**HISTORIC LANDMARK COMMISSION**  
**APPLICATION FOR A CERTIFICATE OF APPROPRIATENESS**  
**DECEMBER 13, 2023**  
**C14H-1996-0003; HR-2023-149027; GF-2023-149122**  
**BARTHOLEMEW-ROBINSON BUILDING**  
**1415 LAVACA STREET**

Restore the front half of the building and construct an addition at the rear.

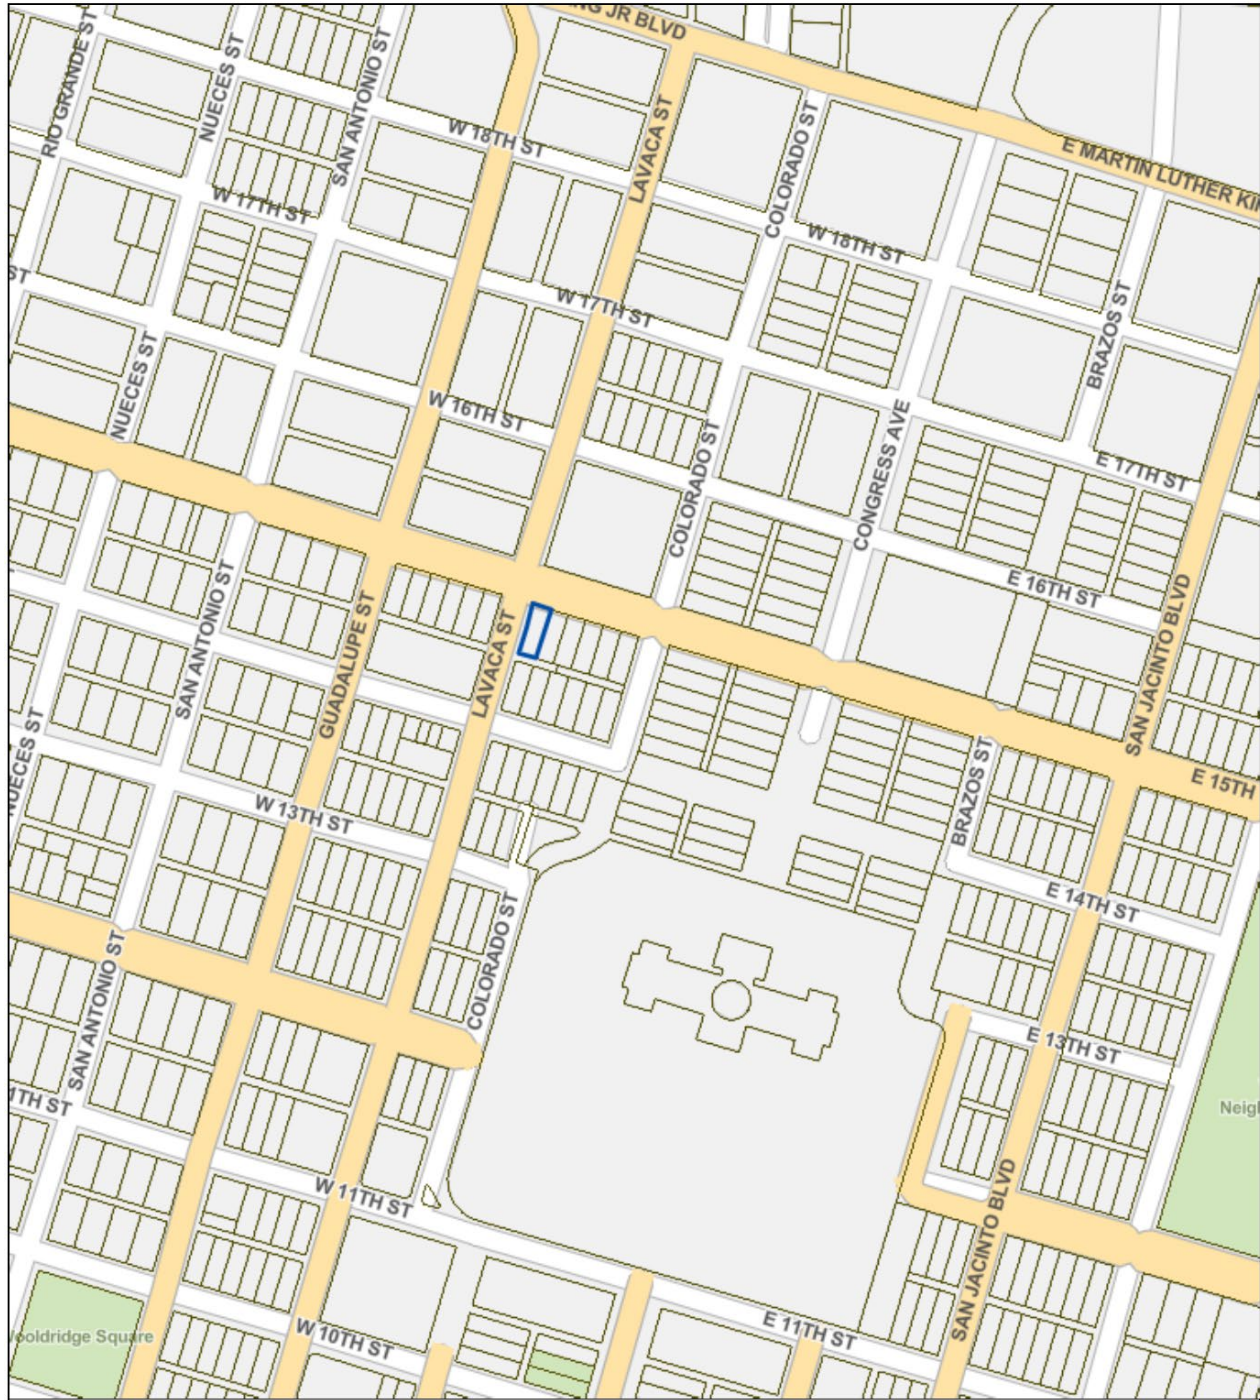
Increase transparency of new structure and reduce its visual complexity. Step new materials back from original building as much as possible.

Request that the applicant use transparent balcony railings rather than aluminum planters and that the new addition be set back as much as possible from the original building, but approve the application as proposed. The applicant has amended the design to respond to staff and Committee feedback on increasing the addition's compatibility.
